Agenda Ordinary Council Meeting

Tuesday 20 October 2009

The purpose of this report is to seek Council's endorsement of the proposed submission to the Department of Planning on the Major Project Application (Concept Plan and State Significant Site Application) for the Bilambil Heights "Rise" Residential Community Development (MP08_0234).

Extract from Concept Plan with Local Area Structure Plan Image:

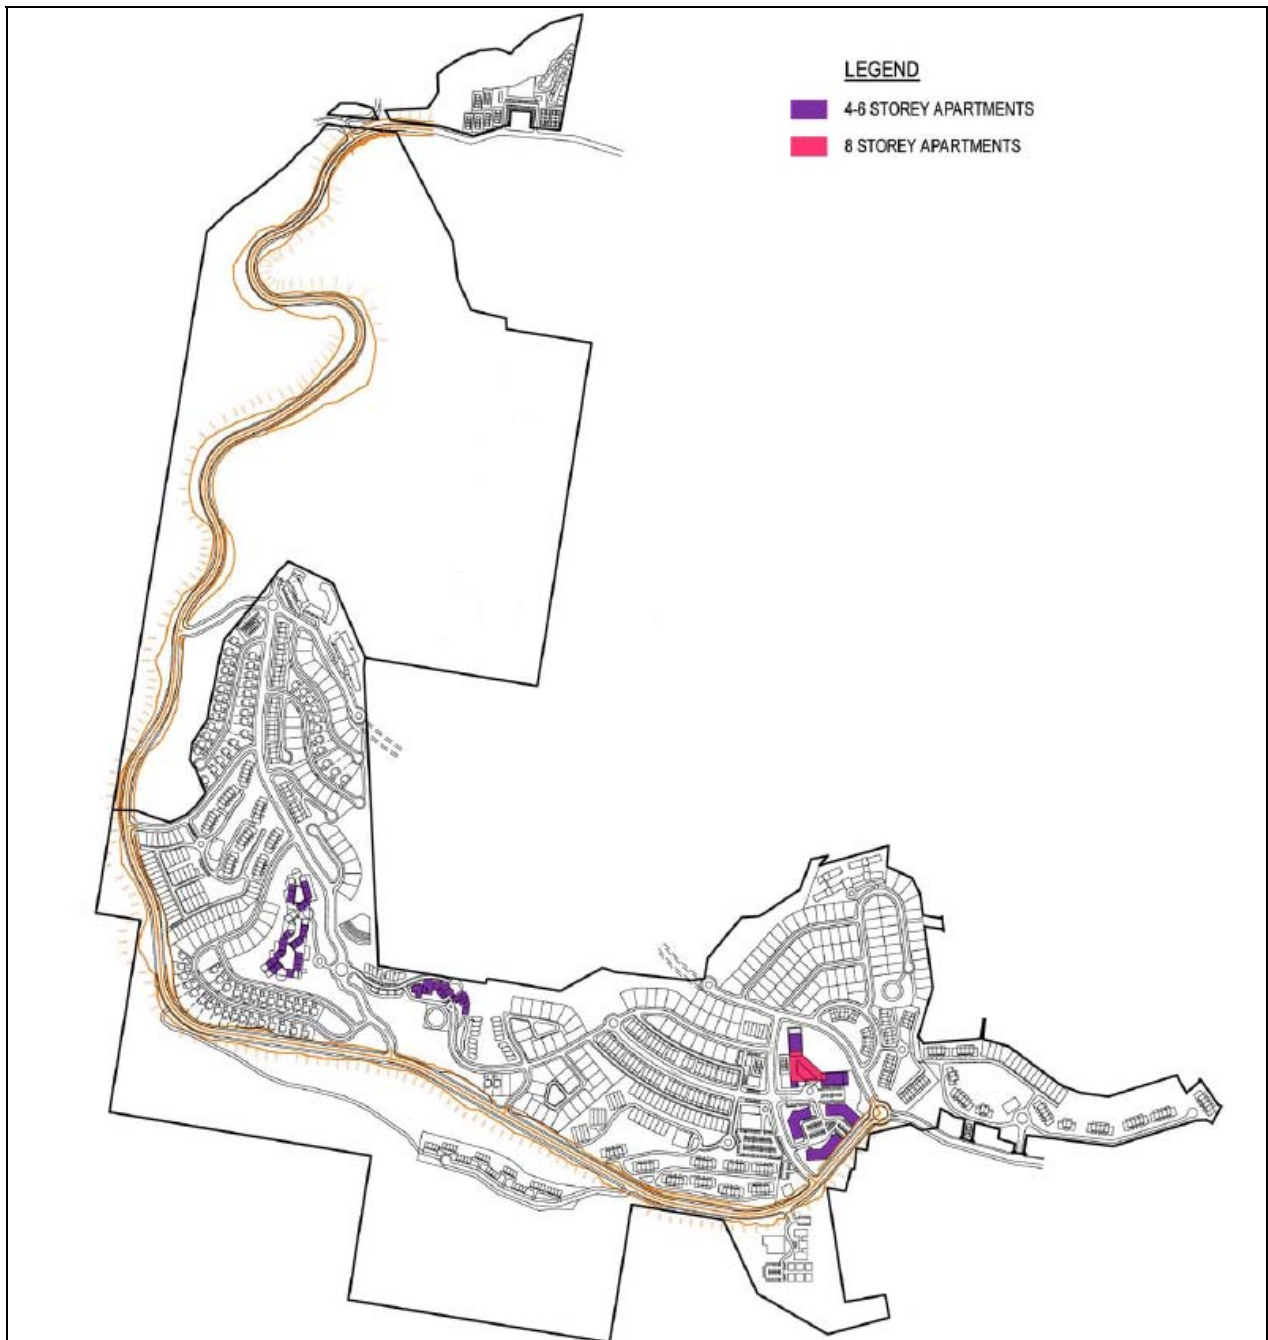
The Local Area Structure Plan was not publically exhibited and was never formally reviewed or reported to Council for any resolution. However, the applicant has indicated that verbal feedback was given by Council staff regarding the comprehensive nature of the Plan.

It is now understood that the Department of Planning has determined that the subject site (Rise) is large enough in its own right to be regarded as a State Significant Site independently of any other adjoining land that forms part of the Bilambil Heights Urban Land Release Area.

Whilst this might be true should the Department approve this concept plan it will have ramifications for Council's future planning of the remainder of the release area.

Council will need to re-consider the Strategic Planning options associated with Bilambil Heights and review whether the Local Area Structure Plan can or should be used as a basis for any future planning. Subsequently it is recommended:

That Council request that a report is brought forward outlining the options available to advance the strategic planning for Bilambil Heights Release Areas (including options in regards to the status of the Local Area Structure Plan prepared on behalf of the "Rise" development)

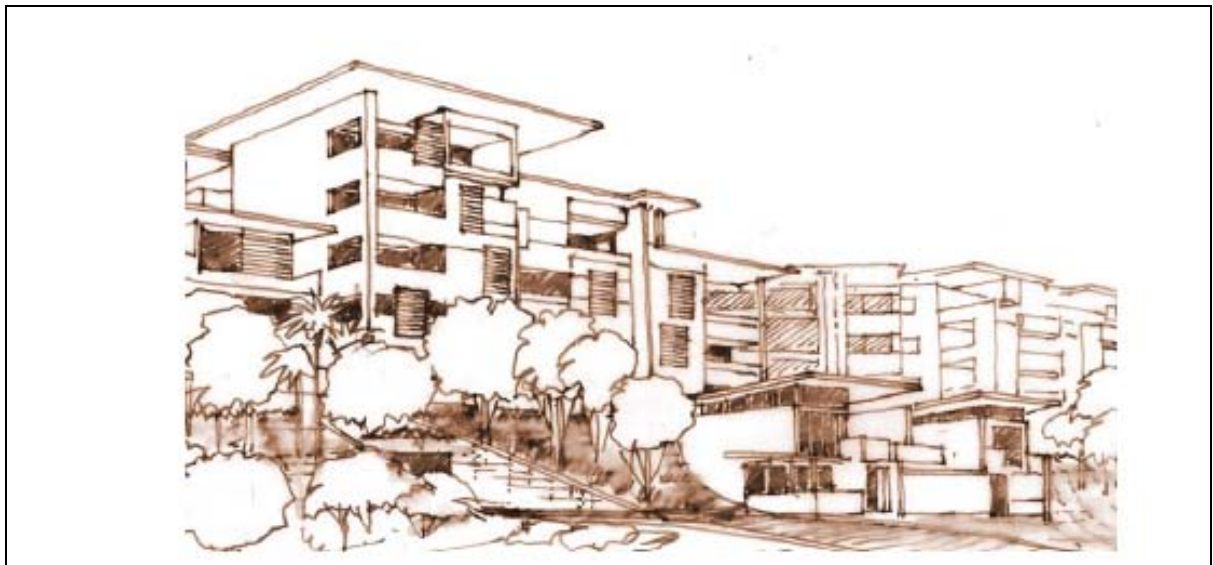
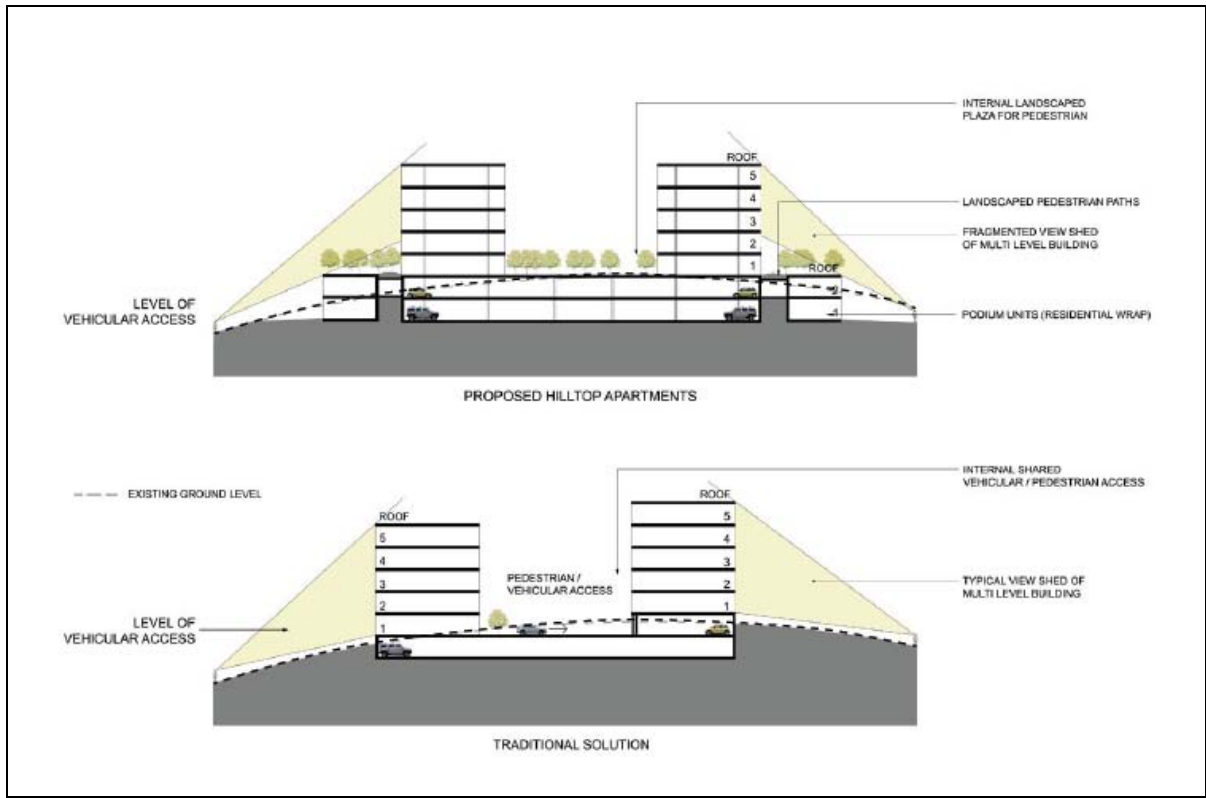
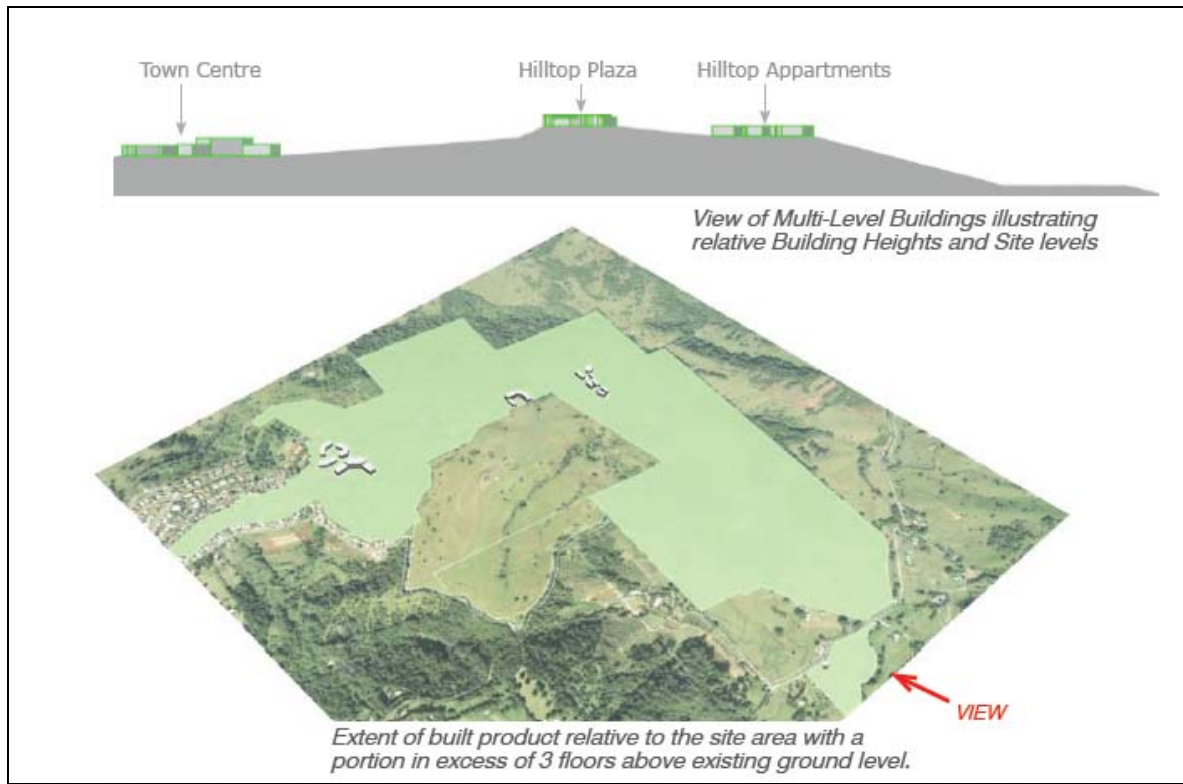
The visual amenity of the existing site and of the proposed development were assessed by observation and analysis when seen from frequently and, in some cases, less frequently accessed public locations, such as roads and streets from which the site is currently visible.

Although not as important as views from public spaces, similar views would also be obtainable from private properties near to the selected streets from which the observations were made.

There are few locations from which the full extent of the site forms an important element in the view shed and even when it does, other existing urban developments are either more visually dominant or are more apparent.

Viewed from locations where the site is quite visible, the parts of the site which are quite obvious will remain as open space and the parts of the site which will be subject to urban development will be visually subservient or screened from those viewpoints.

From the locations where proposed structures which exceed three storeys will be visible, they will not negatively impact the visual landscape due to building heights being restricted to mature native tree height, neutral colour selection for building finishes and distance from Viewpoints.

The application has not satisfactorily demonstrated the public benefit associated with the proposed increase in height and accordingly it is recommended to the Department of Planning to retain the existing height limits in place for the site.

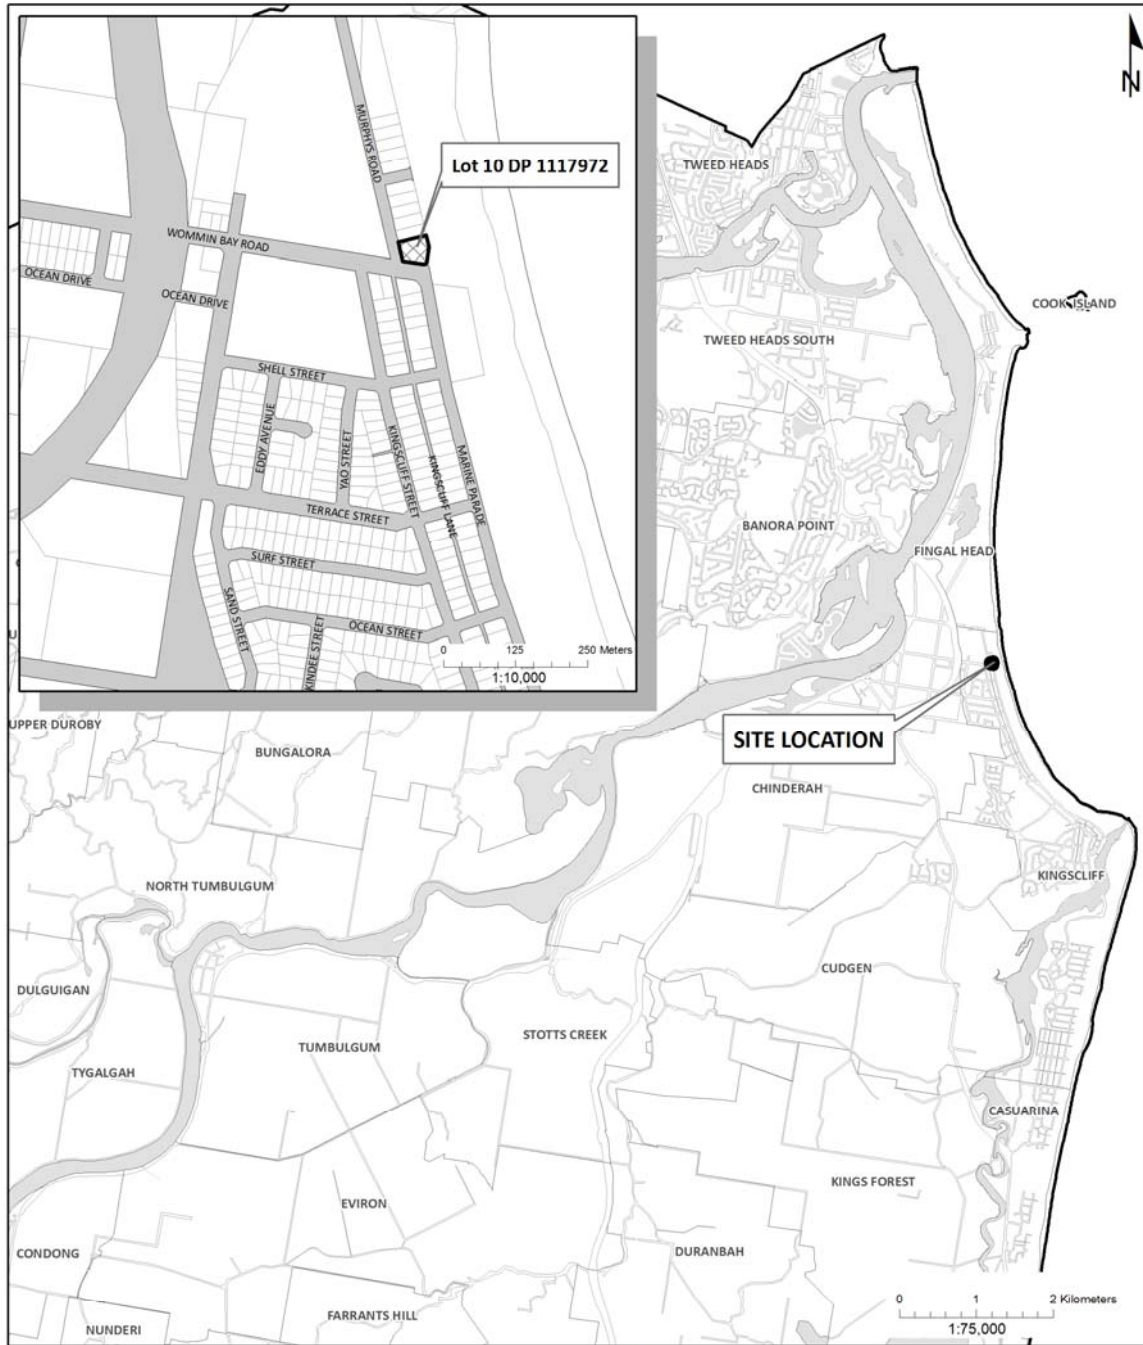
- *The shadow diagrams at Figure 3 show the extent of overshadowing by the existing and proposed buildings. Although the area of shadow will increase, it is still relatively minor (1205m²) in the context of the total area of foreshore reserve.*

- *In June shadows from the proposed building will increase by 205m² compared to the existing building, however, this is numerically insignificant.*
- *The area likely to be overshadowed prior to 3pm mid winter is 205m² and prior to 6.30pm mid summer is 1205m², which is numerically insignificant given the total foreshore and beach area available at Kingscliff.*

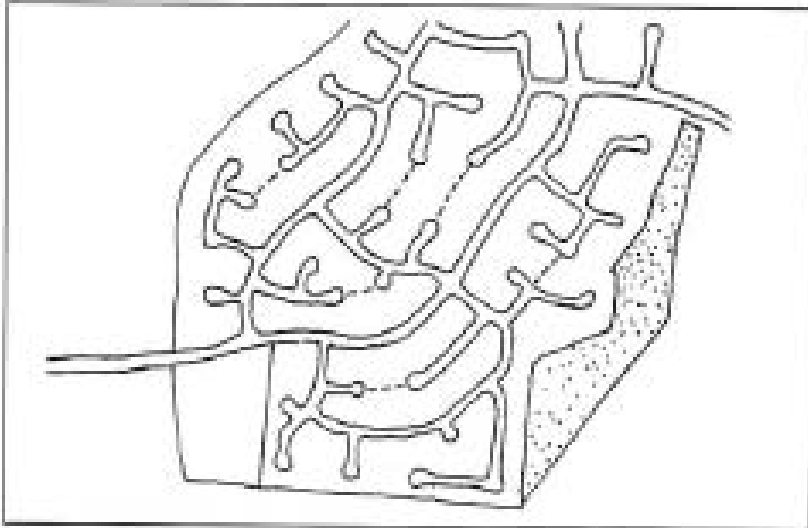
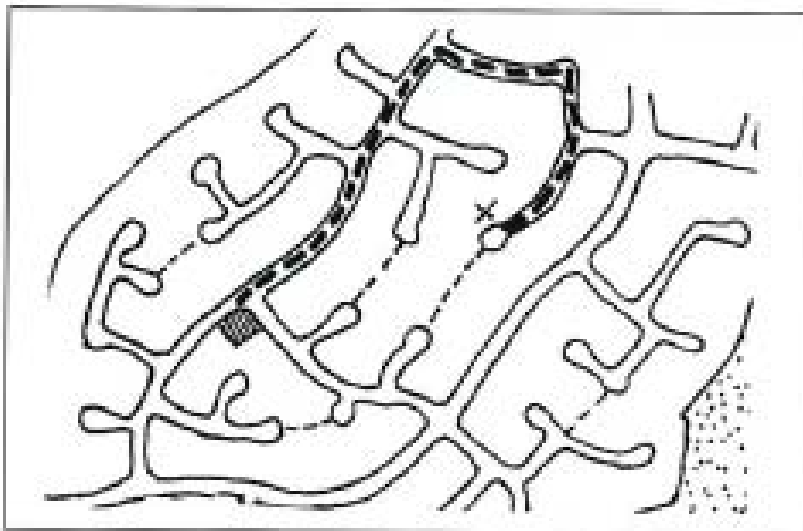
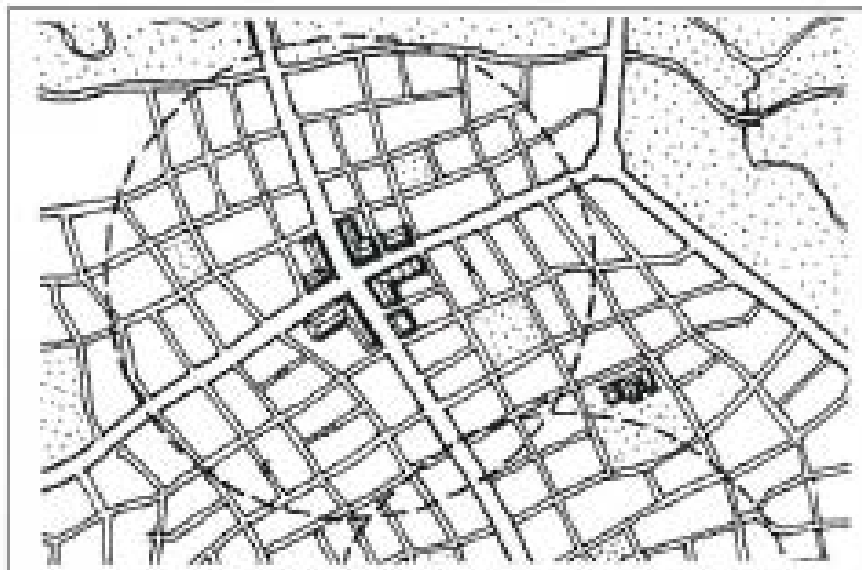
Below is some examples of how streets should **not** look like:

Conventional neighbourhood planning separates functions on a curving, hierarchical street network.

Too many dead end streets and random curving is disorienting and funnels traffic onto high volume roads.

A long, dead end road is a poor quality cul-de-sac. This type of road creates confusing street patterns.

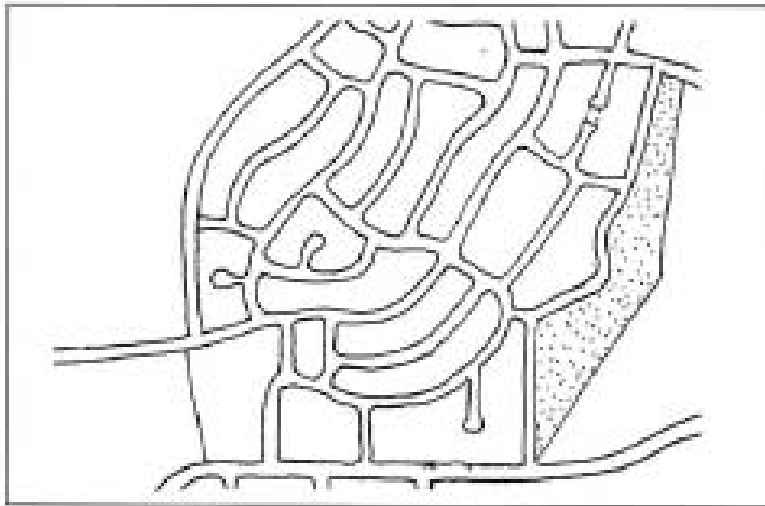
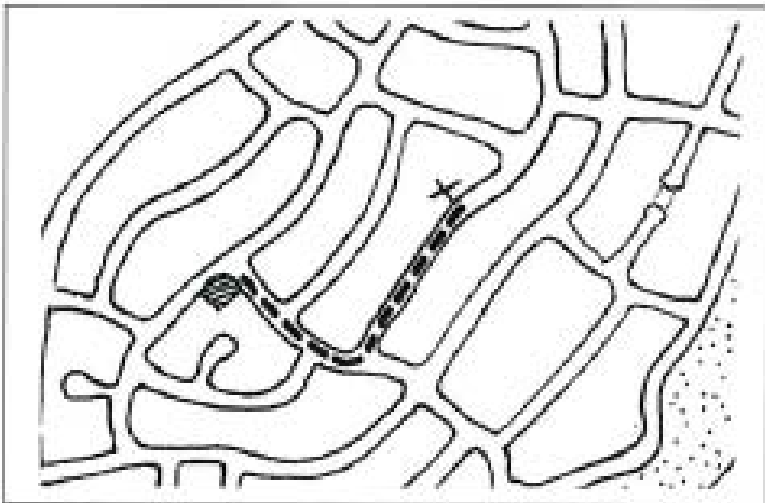
Below is a series of examples of how streets **should** look like:

Traditional neighbourhood planning co-locates activities on a connected street system.

Connected slow speed streets create legible places without the undesirable effects of through traffic. Cul-de-sac are possible within a connected street pattern when used infrequently or to solve a difficult block geometry.

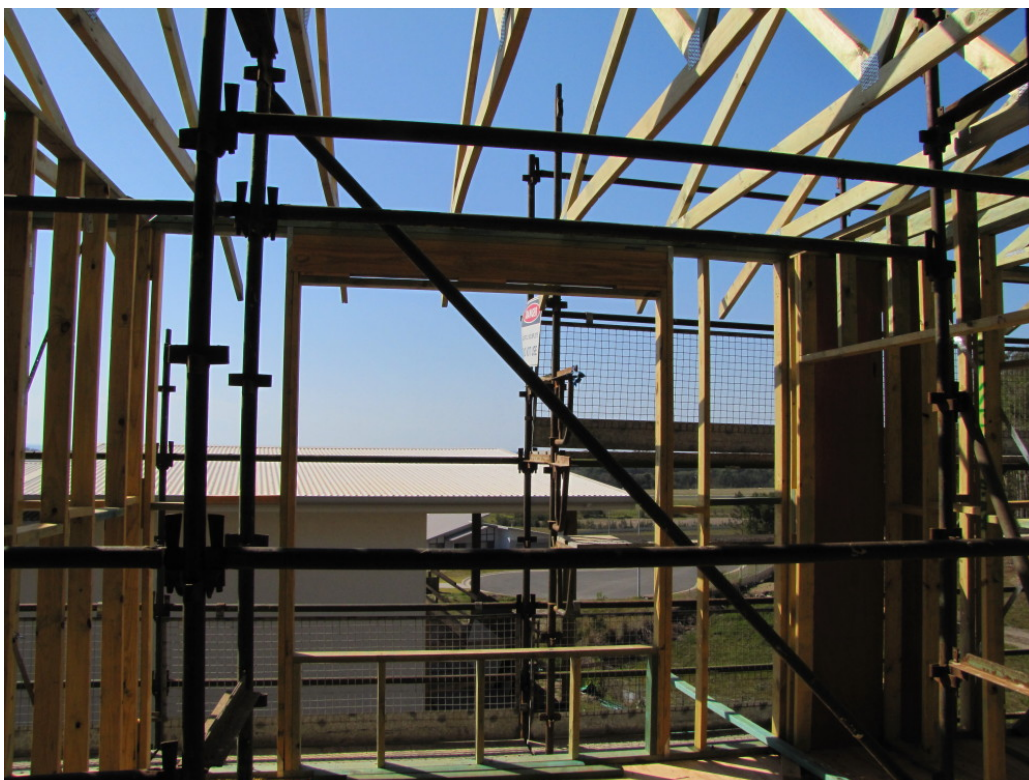
Photo 1 (above) depicts the subject property (which is seeking approval for an increased height limit of 125mm for the constructed home) on the left and the objector's home (which is also under construction) on the right.

Photo 2 (above) is taken from the objector's home presently under construction and indicates that at this section of the house the horizon is not visible over the roof of the house at the subject property.
